## Determination 2018/020

# The refusal to issue a code compliance certificate for a 9-year-old house with rammed-earth walls at 107 Harleston Road, RD1, Sefton

**Figure 1: Approximate plan**

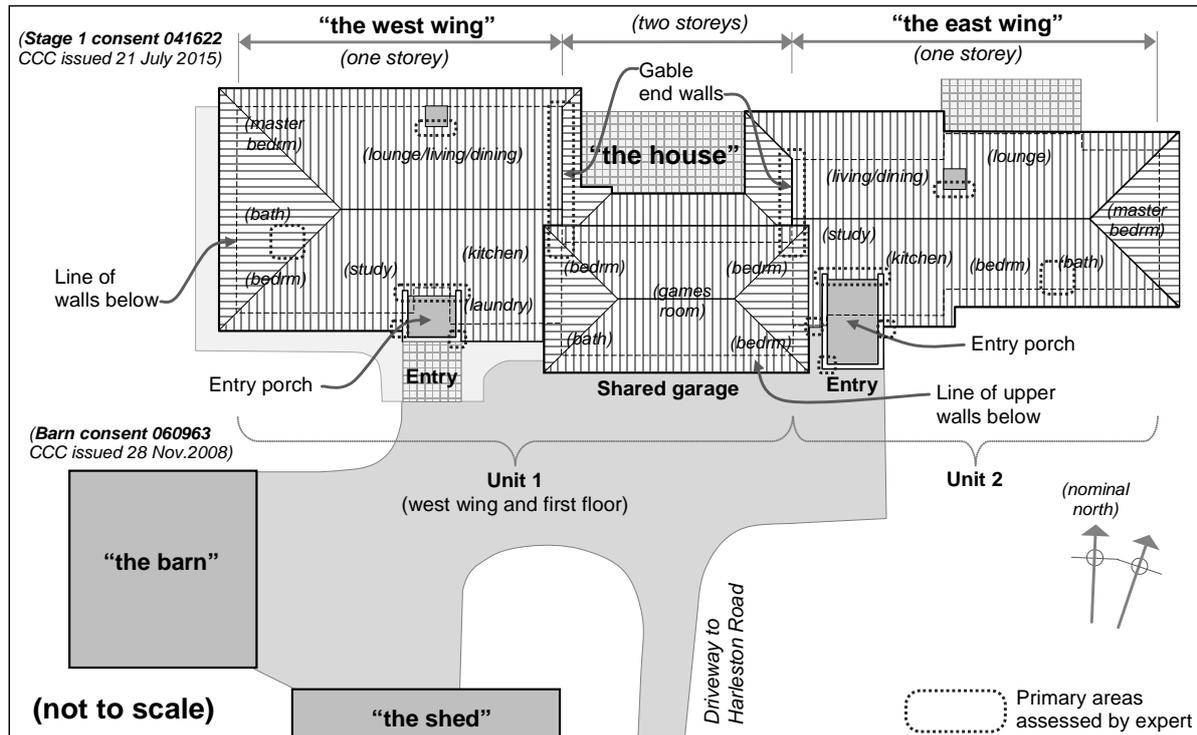
5.2.1 The expert inspected the external building envelope of the house, taking into account the age of the building work and the risks applying for particular junctions and intersections. (Refer to Figure 1 for locations of significant observations.)

- although water is pooling on some chimney flashings, there is no sign from the roof space below that moisture is penetrating as a result
- although roof/wall junctions at the northeast and northwest corners of the upper level are ‘poorly detailed’, there is no water staining or other evidence of moisture penetrating the junctions
- a large gap risks rodent entry into the roof space at the top of the valley below the upper northeast corner
- the bottom of the apron flashings to each side of the entry porches lack effective kickouts to prevent water from penetrating behind the AAC cladding, with staining of exposed timber visible on the west side of the east porch.

- the earth specialist advises that vertical cracks showing in some photographs are typical of those generated by vertical reinforcing rods and are not considered to be of structural concern; such cracking can be addressed with regular inspection and maintenance of the earth wall surfaces
- although drummy in places, the modified plaster system appears to be ‘generally sound and well adhered’, with the mesh able to hold the system together
- areas where plaster has chipped away are well sheltered under deep eaves, and minor repairs and maintenance should provide adequate protection
- vent grilles to the base of the west wing chimney are not sealed to the plaster.

5.4.1 The expert concluded that the following areas do not comply with the Building Code (with relevant clauses shown in brackets):

- the bottom of the apron flashings to the entry porches (E2, B2)
- the risk of rodent entry into the roof space (B2)
- the lack of ground clearances to the tops of the gully traps (E1, G13).

**Figure 2: Sketch of typical exterior wall**

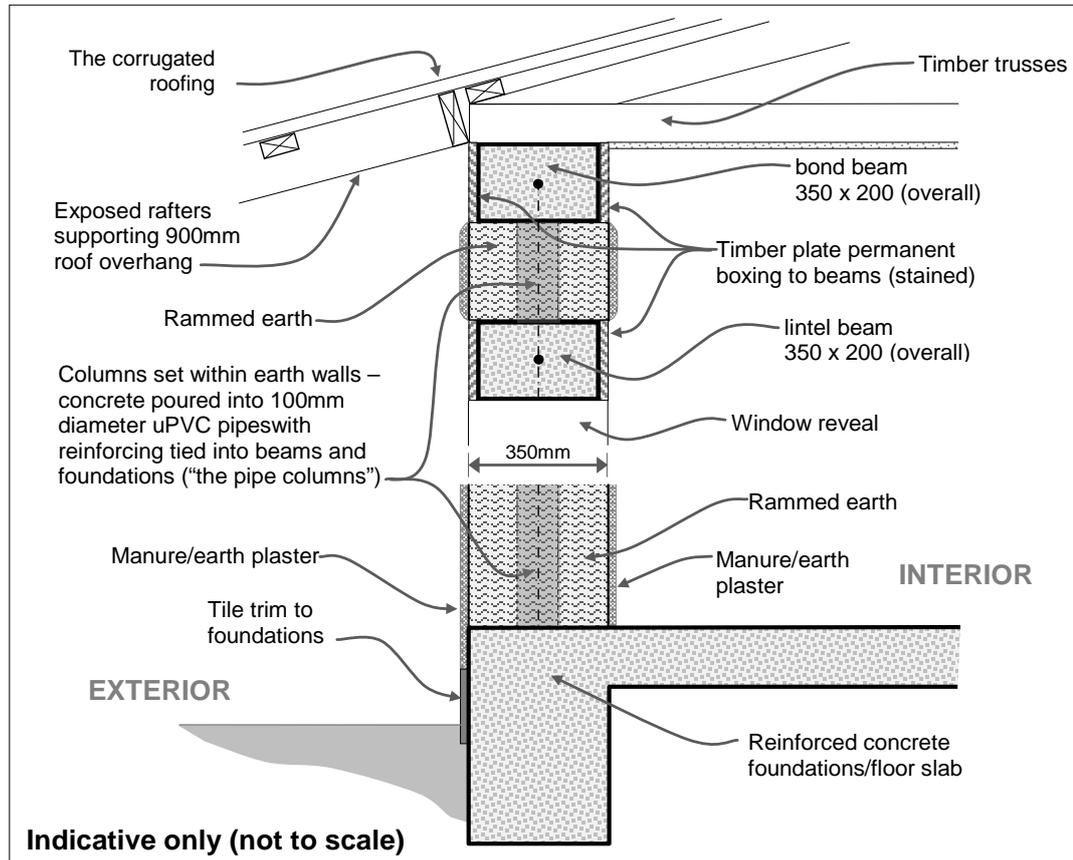
- The permanent timber boxing to bond and lintel beams ‘are well protected under wide eaves and no moisture penetration was evident’. Structural details

for the house (see Figure 2) indicate that the cracking shown in some photos ‘is of minor concern.’
